STATE I/M PROGRAM ADVISORY BULLETIN

APPLICABILITY: 2010 Legacy 2.5GT 6MT

SUBJECT: VECI Label Reference During

NUMBER: 11-165-16

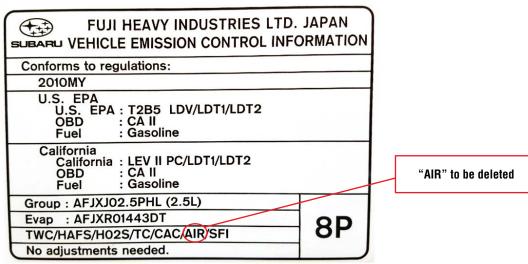
Subaru of America, Inc. has determined that there is a typographical error on the underhood VECI label for Subaru Legacy 2.5GT 6MT models with turbo engine. The incorrect label identifies the vehicle being equipped with secondary "AIR" as indicated below. **The vehicles were correctly built without secondary AIR.** The typographical error has no impact on emission performance or drivability. The remainder of the 2010 model year Subaru VECI label is correct.
